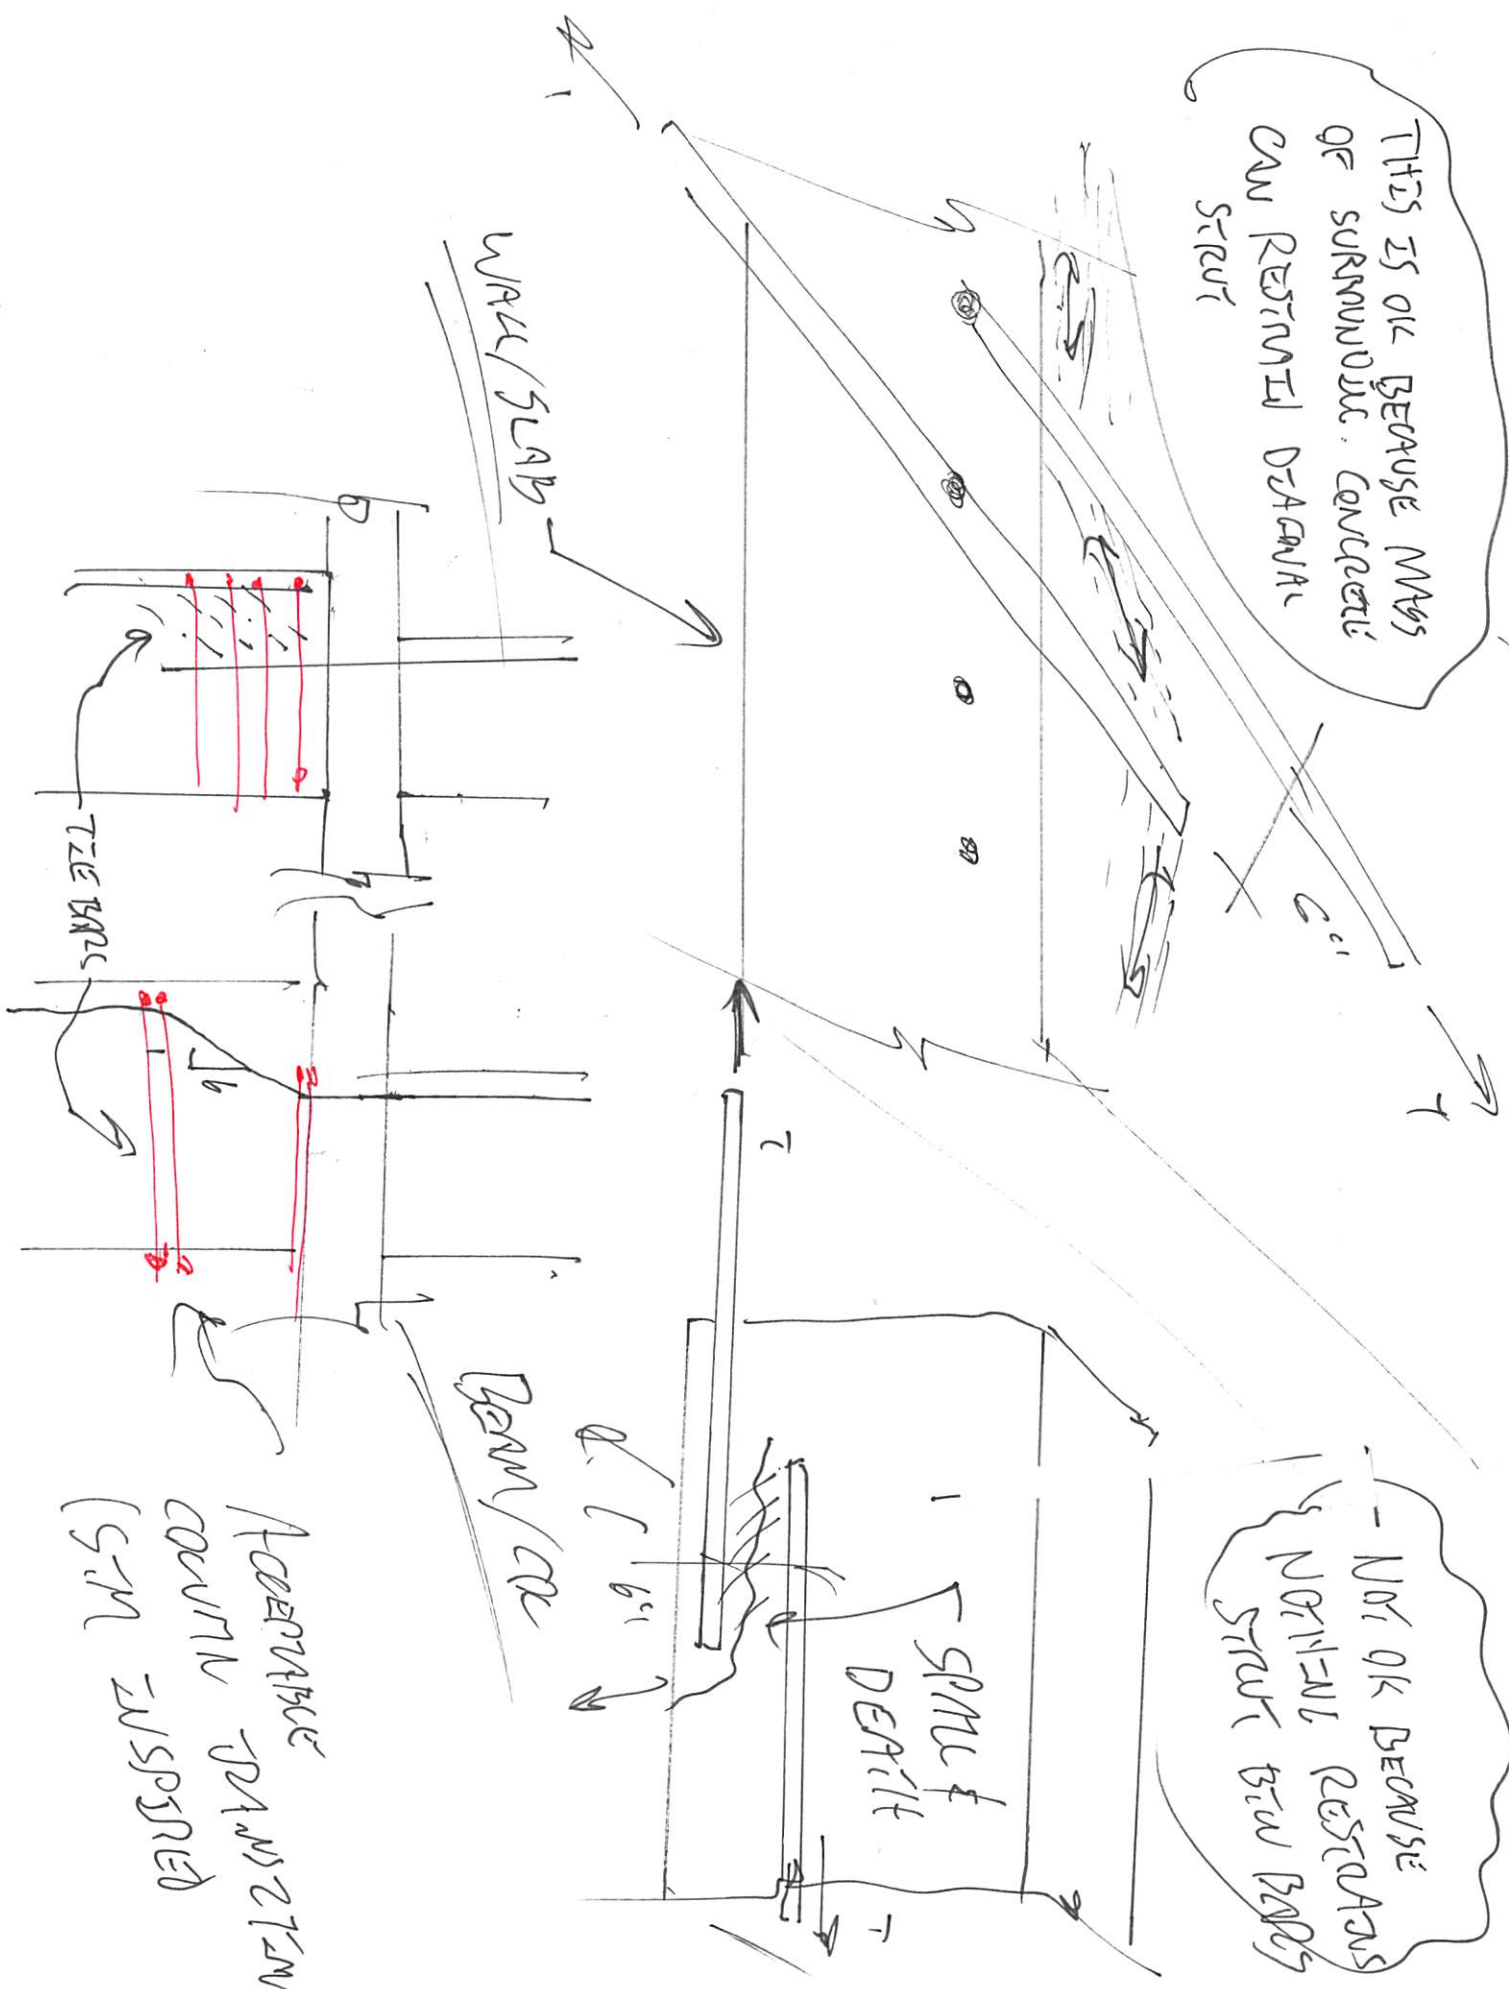
THIS IS OK BECAUSE MASS OF SURROUNDING CONCRETE CAN RESTRICT DIAPHRAGM STRUT

- NOT OK BECAUSE NON-TYPICAL RESTRAINTS STRUT BETWEEN BEAMS
